SUBJECT: Response to Request for Additional Information – Palisades Nuclear Plant 2015 Steam Generator Tube Inspection Report (CAC No. MF7554)

Palisades Nuclear Plant
Docket 50-255
Renewed Facility Operating License No. DPR-20

Response to Request for Additional Information Palisades Nuclear Plant 2015 Steam Generator Tube Inspection Report

Figure E-1: Axial ODSCC NDE Depths

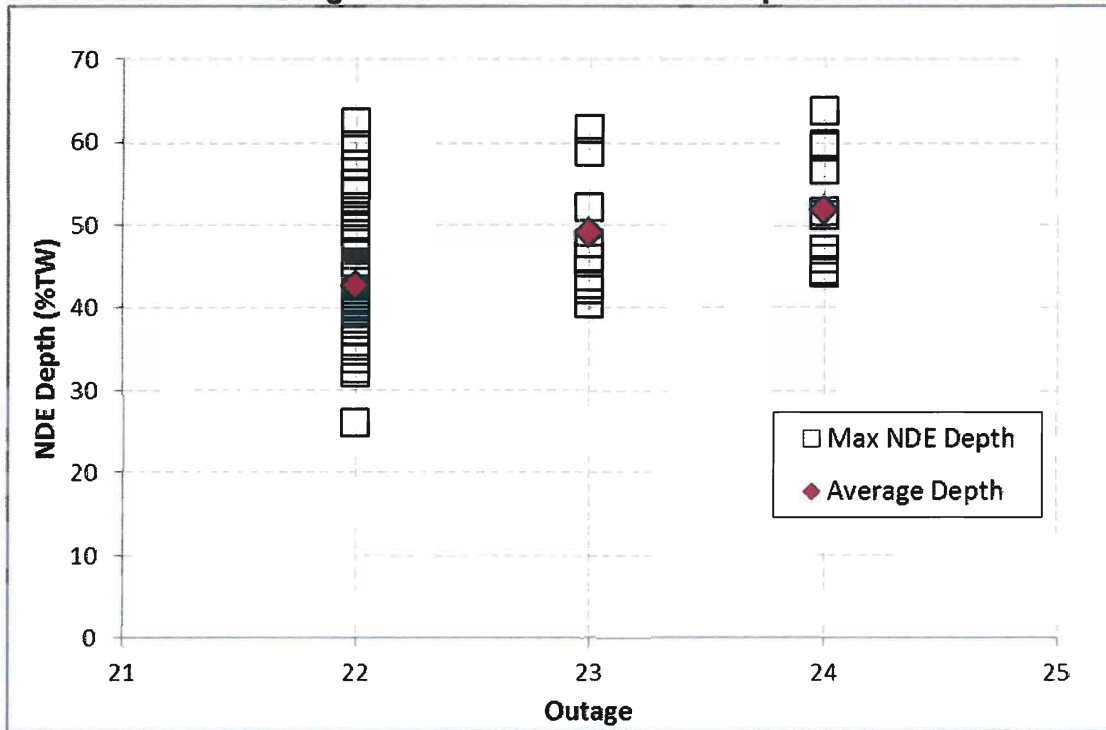
2. *A few of the axial outside diameter stress corrosion cracking indications had structural depths exceeding 50 percent through wall. Please discuss any trends in the number and sizes of axial outside diameter stress corrosion cracking indications. Please discuss whether data quality during the 2015 outage was comparable to the data quality in prior outages.*

A summary of the axial outside diameter stress corrosion cracking (ODSCC) indications identified during the three most recent SG tube examinations are provided in Table E-1, and in Figure E-1 and Figure E-2. As shown, the maximum reported depth was 63.8% through-wall (TW) at 1R24, which is within approximately 2% of the maximum depths reported at both 1R22 and 1R23. The average reported depth was somewhat higher in both 1R23 and 1R24; however, due to the relatively small number of indications reported during 1R23 and 1R24, this difference is not considered to be meaningful. It is also noted that the durations of Cycles 23 and 24 were somewhat longer than that of Cycle 22. A longer operating duration would tend to produce deeper indications and this effect may account for the observed difference in average depth. In summary, the TW depths of axial ODSCC indications have remained relatively stable and the

number of reported indications in 1R23 and 1R24 are less, by more than a factor of 3, than those reported in 1R22.
